<b>PCN Number:</b>	20150904001	<b>PCN Date:</b>	09/29/2015
<b>Title:</b>	Carrier Tape Change for Selected SC70 Packaged Devices		
<b>Customer Contact:</b>	<a href="#">PCN Manager</a>	<b>Dept:</b>	Quality Services
<b>Proposed 1<sup>st</sup> Ship Date:</b>	12/29/2015		
<b>Change Type:</b>			
<input type="checkbox"/>	Assembly Site	<input type="checkbox"/>	Assembly Process
<input type="checkbox"/>	Design	<input type="checkbox"/>	Electrical Specification
<input type="checkbox"/>	Test Site	<input checked="" type="checkbox"/>	Packing/Shipping/Labeling
<input type="checkbox"/>	Wafer Bump Site	<input type="checkbox"/>	Wafer Bump Material
<input type="checkbox"/>	Wafer Fab Site	<input type="checkbox"/>	Wafer Fab Materials
<input type="checkbox"/>		<input type="checkbox"/>	Part number change
<input type="checkbox"/>		<input type="checkbox"/>	Assembly Materials
<input type="checkbox"/>		<input type="checkbox"/>	Mechanical Specification

Texas Instruments is pleased to announce the qualification of a new carrier tape for selected devices in the SC70 package. The material composition between the 2 carrier tapes is the same. A dimensional comparison summary is below:

New Carrier tape Dimensions:

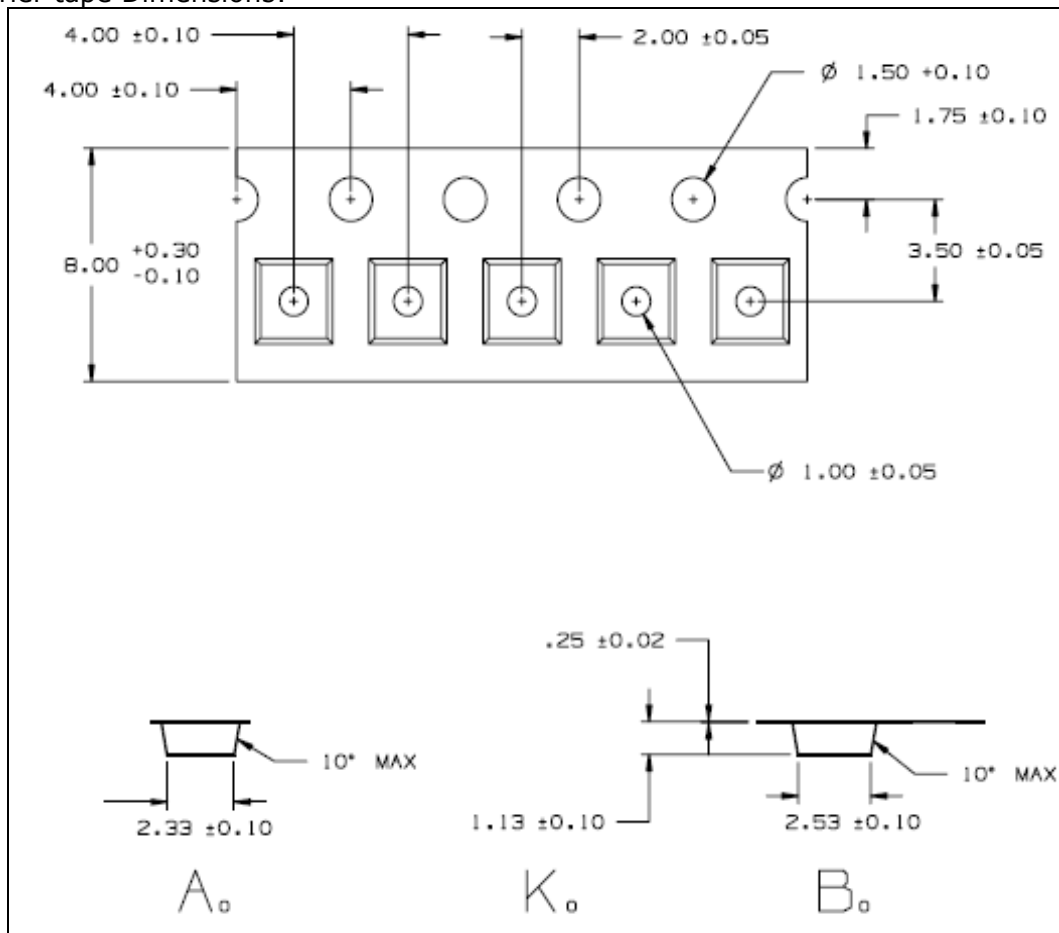
Dimension	From	To
Ao	2.25 (+/- 0.1) mm	2.33 (+/- 0.1) mm
Bo	2.40 (+/- 0.1) mm	2.53 (+/- 0.1) mm
Ko	1.22 (+/- 0.1) mm	1.13 (+/- 0.1) mm

<b>Reason for Change:</b>			
Alignment with EIA 481 SC70 pocket dimensions			
<b>Anticipated impact on Fit, Form, Function, Quality or Reliability (positive / negative):</b>			
None			
<b>Changes to product identification resulting from this PCN:</b>			
New Carrier Tape			
<b>Product Affected:</b>			
SN74LVC1G00DCKJ	LM4040B10IDCKR	REF3320AIDCKT	TLVH431ACDCKT
SN74LVC1G00IDCKREP	LM4040B20IDCKR	REF3320AIDCKTG4	TLVH431ACDCKTG4
V62/04732-01XE	LM4040B20IDCKT	REF3325AIDCKR	TLVH431AIDCKR
SN74LVC1G00MDCKREP	LM4040B25IDCKR	REF3325AIDCKRG4	TLVH431AIDCKT
V62/04732-02XE	LM4040B25IDCKRG4	REF3325AIDCKT	TLVH431AQDCKR
SN74LVC1G08DCKJ	LM4040B30IDCKR	REF3325AIDCKTG4	TLVH431AQDCKT
SN74LVC1G08IDCKREP	LM4040B30IDCKRG4	REF3330AIDCKR	TLVH431BCDCKR
V62/04733-01XE	LM4040B41IDCKR	REF3330AIDCKRG4	TLVH431BCDCKT
SN74LVC1G08MDCKREP	LM4040B50IDCKR	REF3330AIDCKT	TLVH431BCDCKTG4
V62/04733-02XE	LM4040C10IDCKR	REF3330AIDCKTG4	TLVH431BIDCKR
